Product Change Notification

Product Group: TC/Thursday July 30, 2026/PCN-TC-016-2026-REV-0

Enhanced T55/T56 multi anode D-case capacitor construction

T55 and T56 series case D – New construction

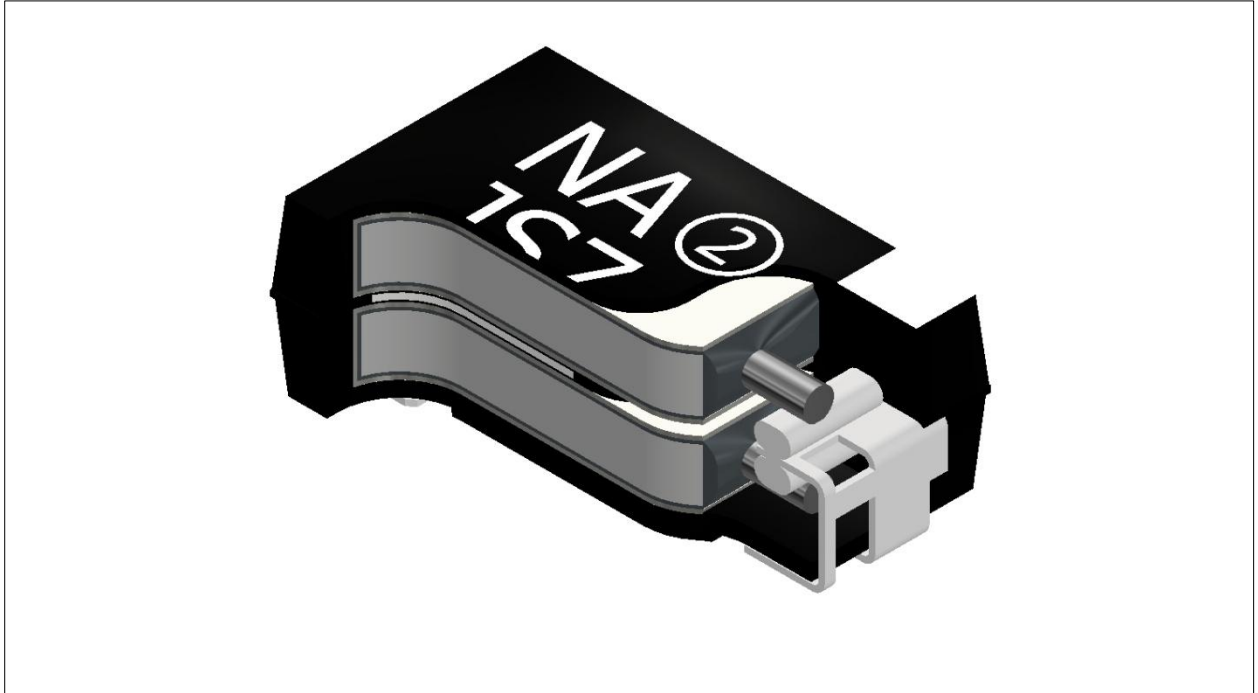
Description of Change: Redesigned dual anode architecture with optimized anode orientation changed from stacked to side-by-side.

Reason for Change: Side-by-side orientation of anodes provides direct connection to a lead frame, improved manufacturability and lower ESR values.
